REMARKS

In the present application, claims 1-27 are pending. Claims 1-3, 5-6 and 8-13 are rejected, and claims 1, 8-9, 11-12, 14-17, and 22 are objected to in the present Office Action. Claims 18-21 and 23-27 are allowed. In response, Applicant is amending claims 1, 4, 7, 8-9, 11-12, 14-16, and 22 and adding new claims 28-29. No new matter is being added. In view of the following amendments and remarks, Applicant respectfully requests reconsideration of the application.

FIG. 7

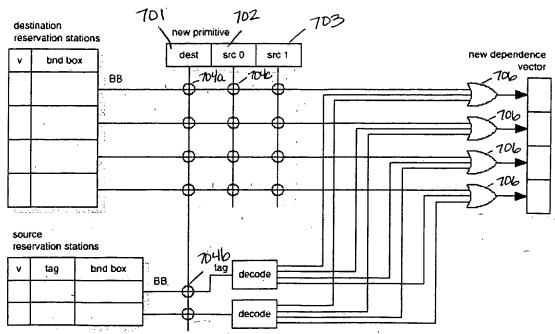
In paragraph 5, the Examiner objected to the drawings under 37 CFR 1.83(a) for not showing every feature of the invention specified in the claims. Specifically, the "first comparator" of claim 14, the "second comparator" of claim 15, the "third comparator" of claim 16, and the "logic OR gate for receiving the first, second, and third resultant bits... primitives" recited in claim 17 must be shown. In response, Applicant is proposing drawing corrections to FIG. 7.

In paragraph 6, the Examiner objected to the drawings for failing to comply with 37 CFR 1.84(p)(5) for not including reference signs mentioned in the description. In response, Applicant is further amending FIG. 7 to include reference numbers for the single destination region 701 and the two source regions 702 and 703.
